ITEM: 6.10	COMMITTEE OF ADJUSTMENT REPORT SUMMARY MINOR VARIANCE APPLICATION FILE NUMBER A183/23 30 DEL FRANCESCO WAY, MAPLE
-------------------	--

**COMMITTEE OF ADJUSTMENT REPORT
MINOR VARIANCE APPLICATION
A183/23
30 DEL FRANCESCO WAY, MAPLE**

PROPOSED BASEMENT UNIT

DRAWING NAME
SITE PLAN

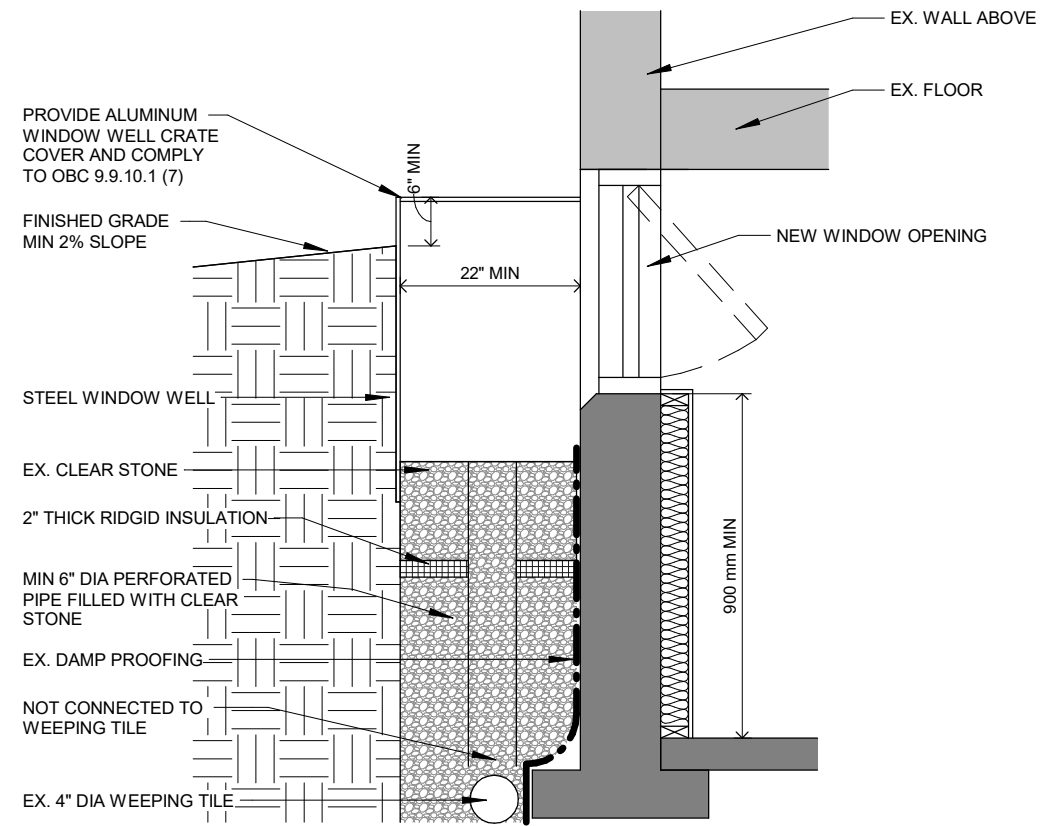
The Owners are requesting relief to permit the construction of a raised landing with access stairs and an unobstructed hard landscape surface walkway to provide access to a proposed secondary suite entrance on the east side of the semi-detached dwelling with the above noted variances.

One window well exists where the walkway is proposed, triggering Variance 1. The pathway would narrow to 0.72 m in-front of the window well. The Development Planning Department has no objection to Variance 1, as the window well projects minimally above grade and will not impede safe access to the secondary suite. The hard landscape walkway maintains the required 1.2 m clear path to the secondary suite entrance at all other locations.

The Development Planning Department has no objection to Variance 2. The proposed secondary suite door is above grade. A landing abutting the door is proposed within the eastern interior side yard with steps on its north and south sides. The stair and landing combination would provide access to the secondary suite door and facilitate exterior access between the front and rear yards. The Development Engineering Department has reviewed the landing and stairs and is satisfied that drainage will be maintained.

Accordingly, the Development Planning Department can support the requested variances and is of the opinion that the proposal is minor in nature, maintains the general intent and purpose of the Official Plan and Zoning By-law, and is desirable for the appropriate development of the land.
